STAFF REPORT

DATE: 09/23/2024
TO: Honorable Chair and Commissioners
FROM: Planning and Development Department

PP2023-0007 (CONTINUED): Precise Plan application for the review of the site plan, architecture, landscaping and other features associated with the development of a 4,110-square-foot automated carwash tunnel with 11 vacuum stalls, gas station with five double-sided fuel pumps, and a 3,725-square-foot convenience store proposed on 1.40 acres, located on the north side of 2nd Street, approximately 450 feet west of Buena Vista Avenue. (Applicant: Greens Development, 16530 Bake Parkway, Suite 200, Irvine, CA 92618)

Project Concerns and Responses

TRASH ENCLOSURE PLAN

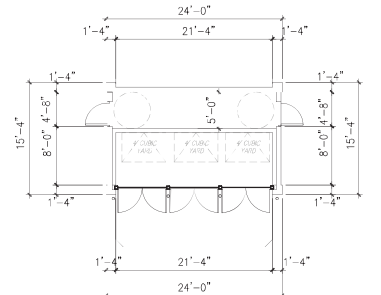
Revise the trash enclosure to include a mesh covering on all four sides to fully enclose the gap between the block enclosure and cover.

- **Response:** The applicant has redesigned the trash enclosure to include a mesh covering from the block enclosure to the cover of the enclosure on all four sides of the enclosure, as requested by the Planning and Housing Commission. The revised trash enclosure plan is attached as Exhibit 7.

- A** STUCCO
- B** METAL AWNING
- C** GLAZING STOREFRONT & WINDOW
- D** LIGHTING FIXTURE
- E** ROOF EQUIPMENT
- F** METAL PANEL
- G** SPANDREL GLASS WINDOW
- H** METAL MESH AT TRASH ENCLOSURE, COVERING ALL (4) SIDES TO FULLY ENCLOSE ALL THE GAP.

EXHIBIT 8

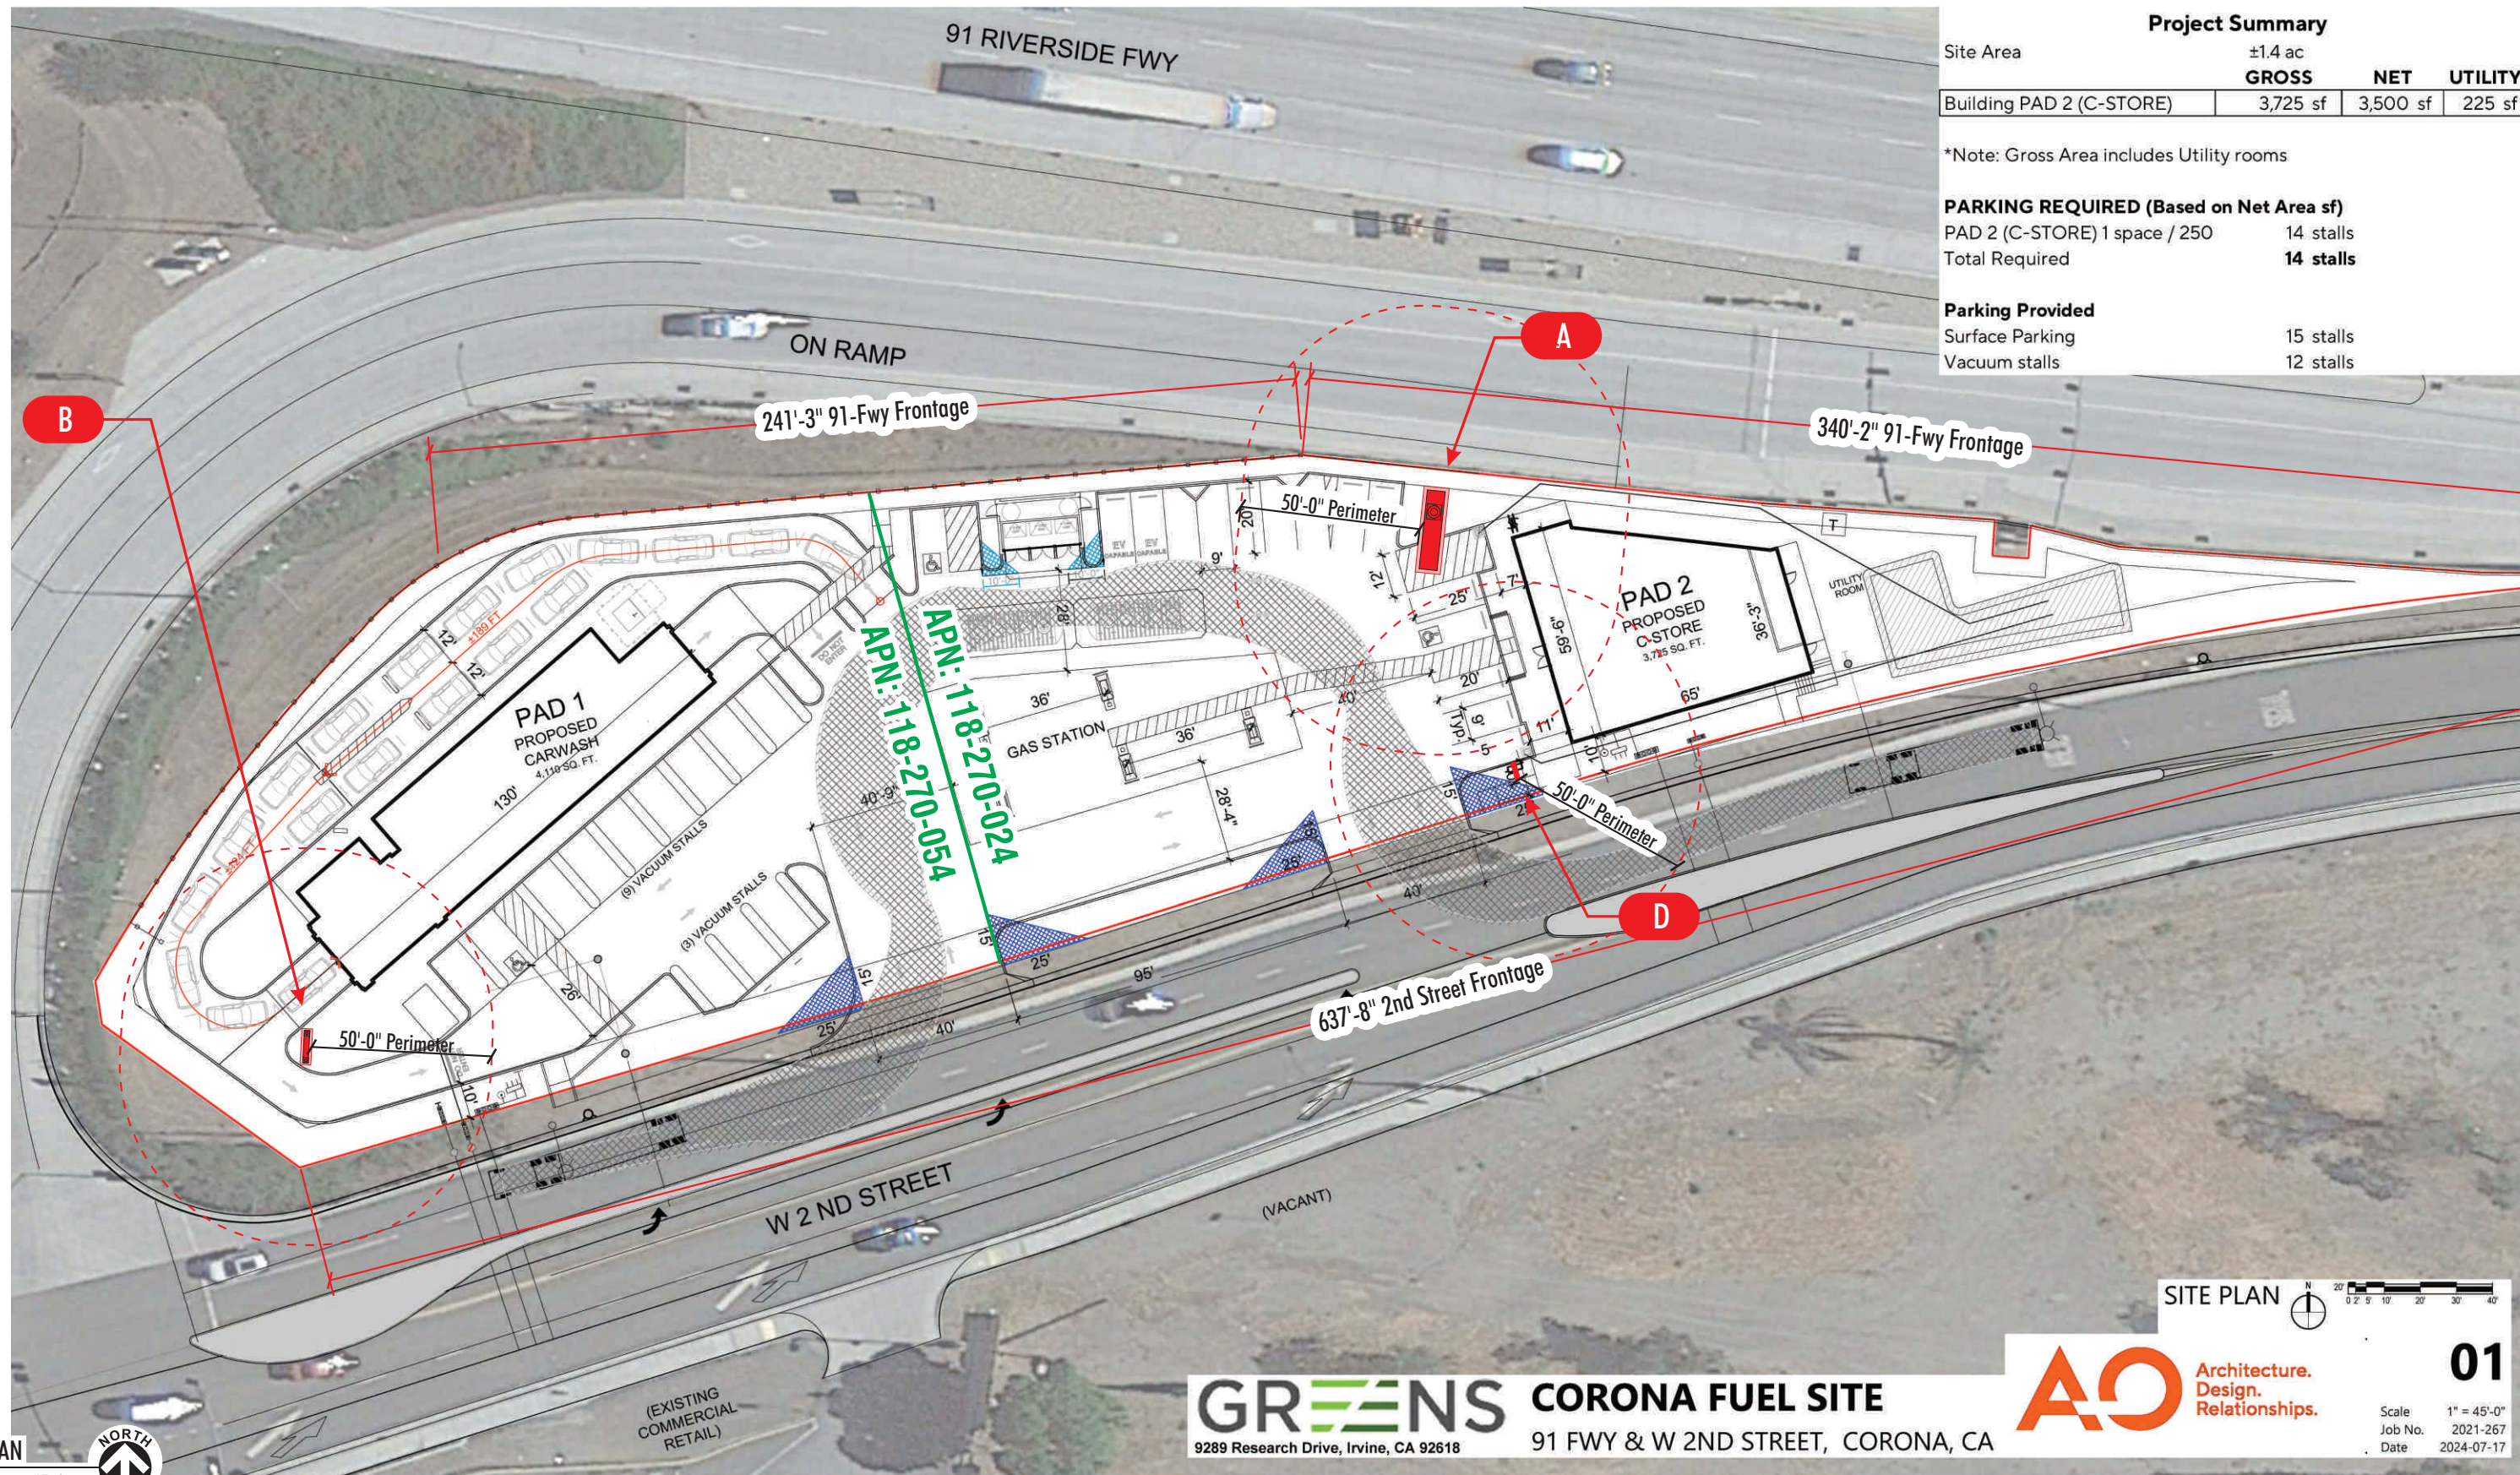
Evaluate and potentially revise the on-site landscaping to discourage homeless encampment/loitering.

- **Response:** The applicant's landscape plan has been revised to include elements that discourage unhoused individuals from loitering. This includes the use of desert plants, rocks and other materials to deter encampments. Additionally, the applicant has removed an outdoor seating area that was previously proposed just north of the convenience store to prevent loitering.

Revisions:
EXHIBIT 9

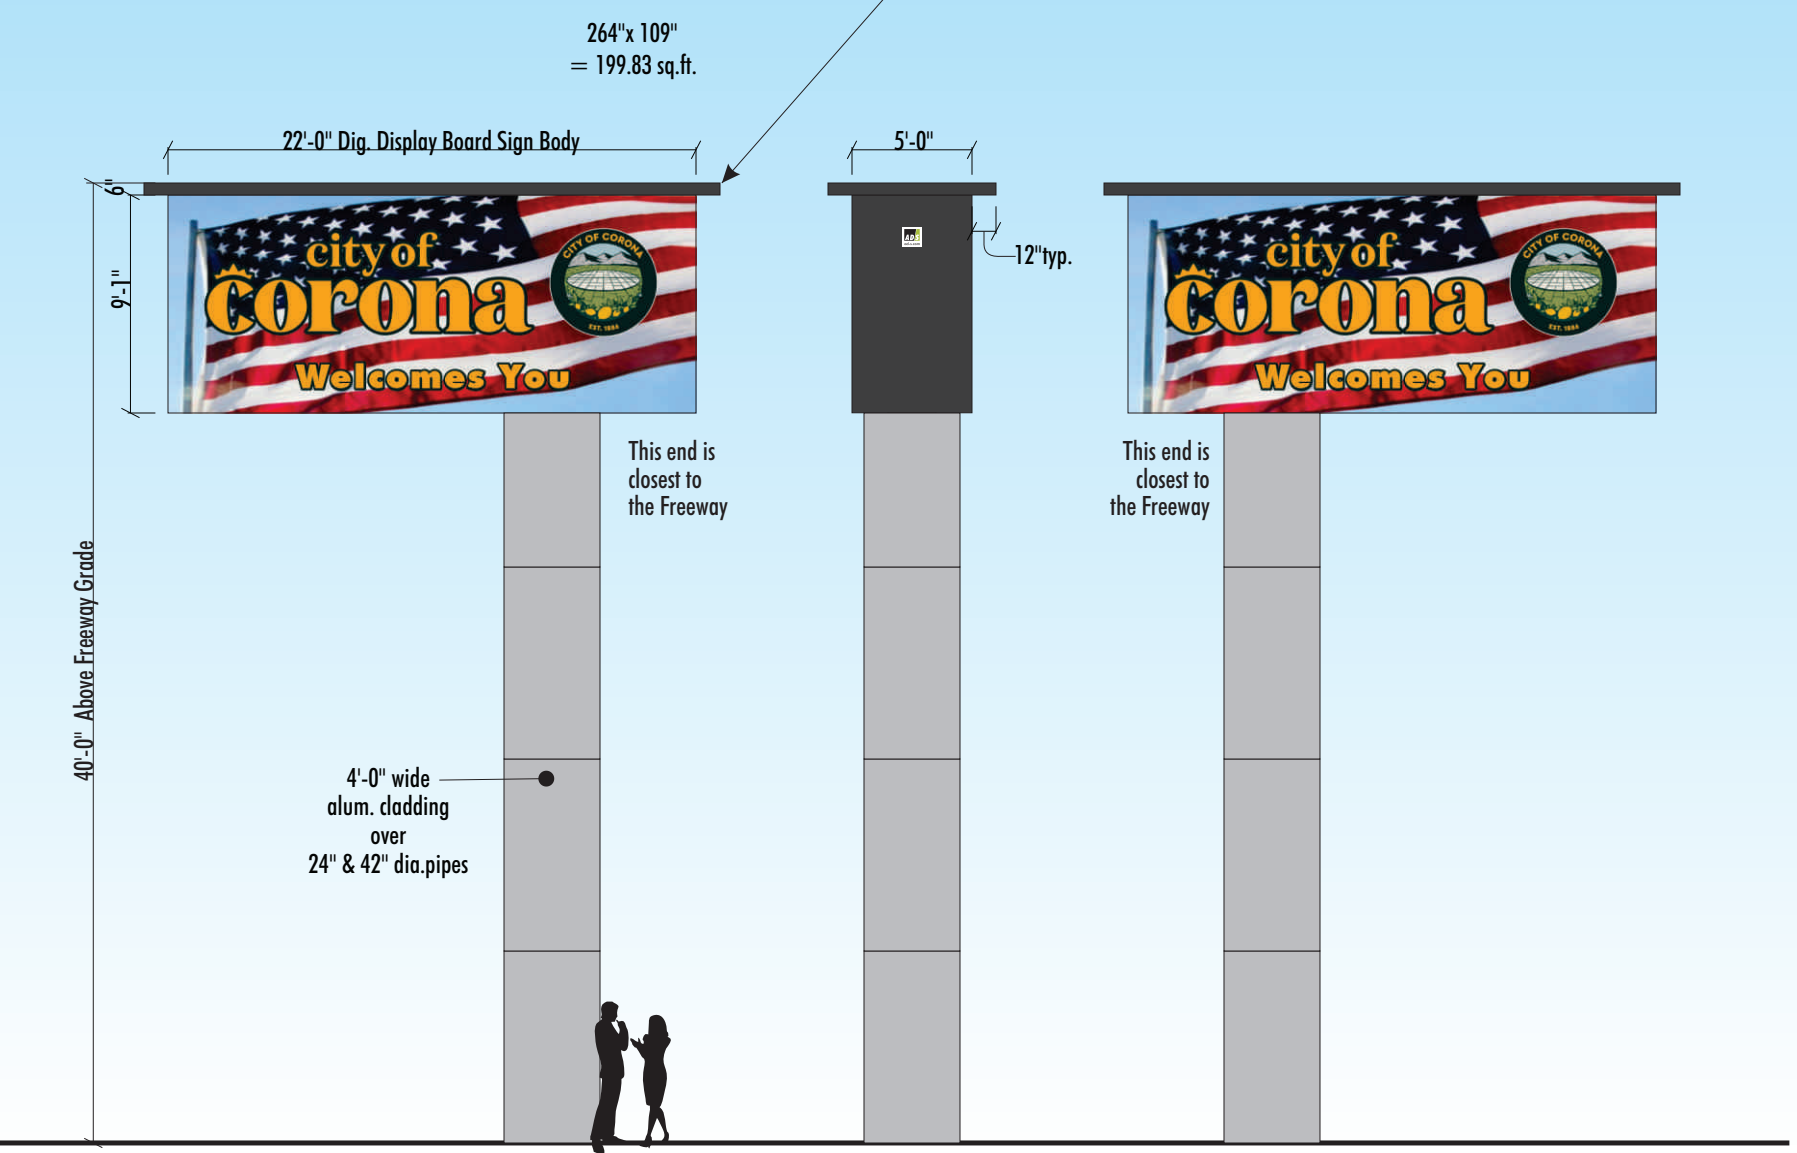
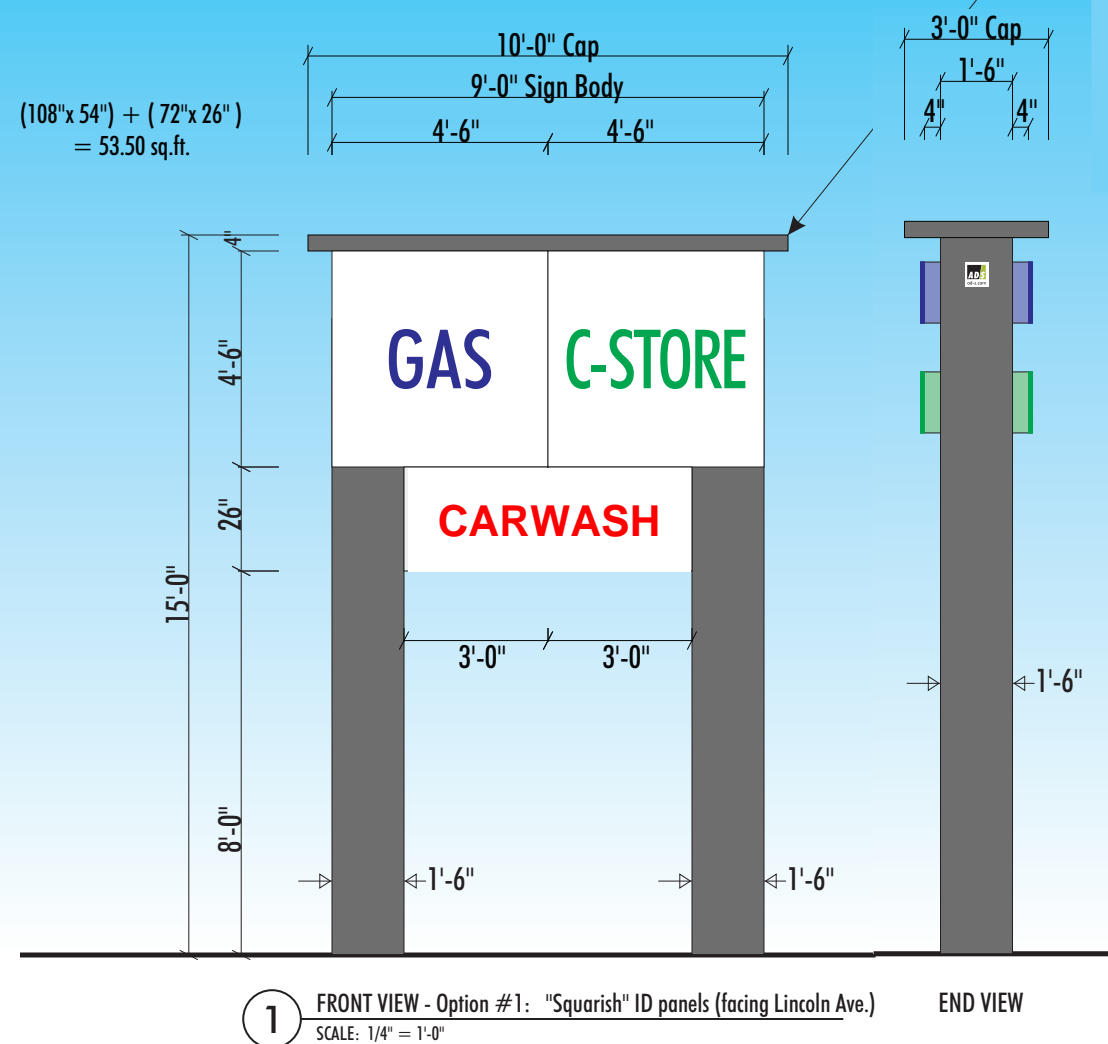
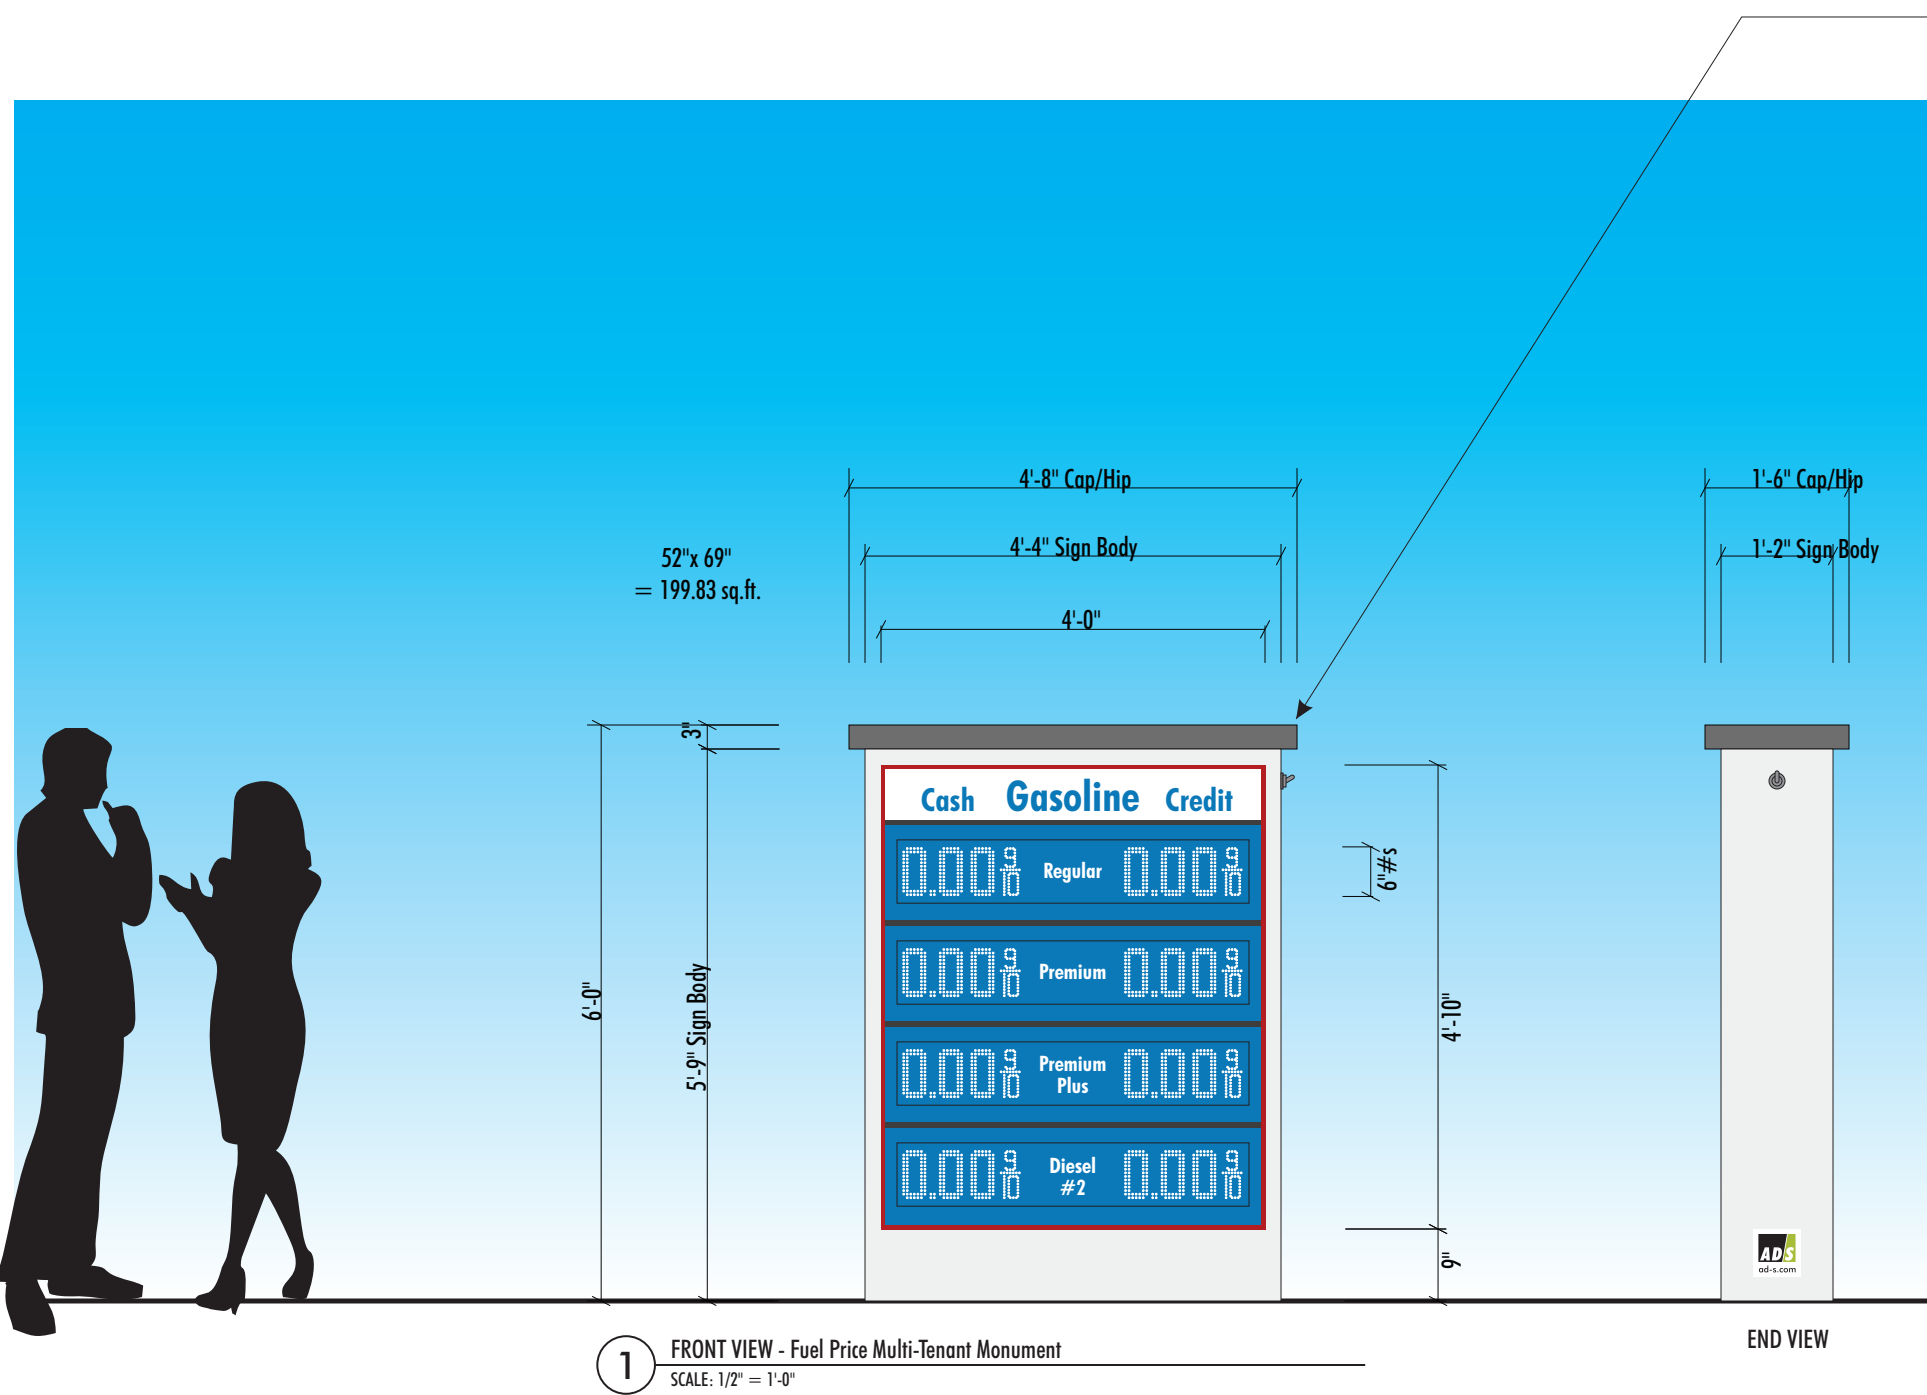
Revise the sign program to meet the Corona Municipal Code’s Sign Ordinance. Additionally, the monument sign proposed on 2nd Street should be placed near the project’s east driveway, away from the busier west driveway.

- **Response:** The applicant has revised the sign program which now fully complies with the Sign Ordinance. The four originally proposed parcel identification signs have been reduced to two signs, consisting of a 15-foot-high pylon sign and 40-foot-high freeway pylon sign with an electronic message board. The monument sign that was proposed at the west driveway has been removed.
